**Origination Form**  
Proposed Revisions to a Standard Plans Index

<b>Originator:</b>	Pinkham, Andrew	<b>Index Number:</b>	430-030
<b>Date:</b>	6/3/2025	<b>Sheet Number(s):</b>	2
<b>E-mail:</b>	andrew.pinkham@dot.state.fl.us	<b>Index Title:</b>	Straight Concrete Endwalls Single and Multiple Pipe

Section A-A

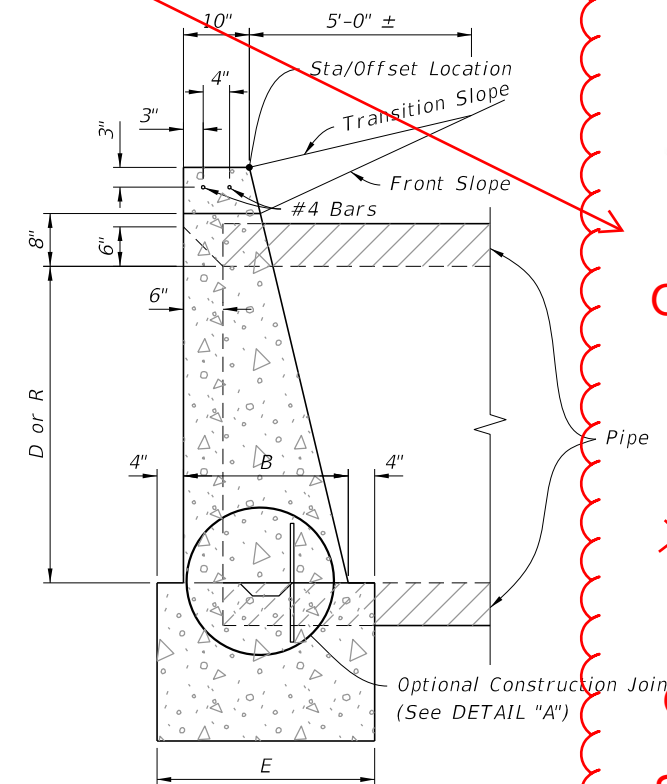
Sheet 2: Added SECTION A-A to show Option I or II.

Addition of alternate to hole forming details and minimum beam height above the opening. Issues with delivered product and at request of Industry. Request came through the Precast Concrete Structures Association to Andrew Pinkham at SMO, through Drainage Design and was signed as an Approved Shop Drawing by State Drainage Engineer.

ADDED:  
Section A-A to show  
Option I or II
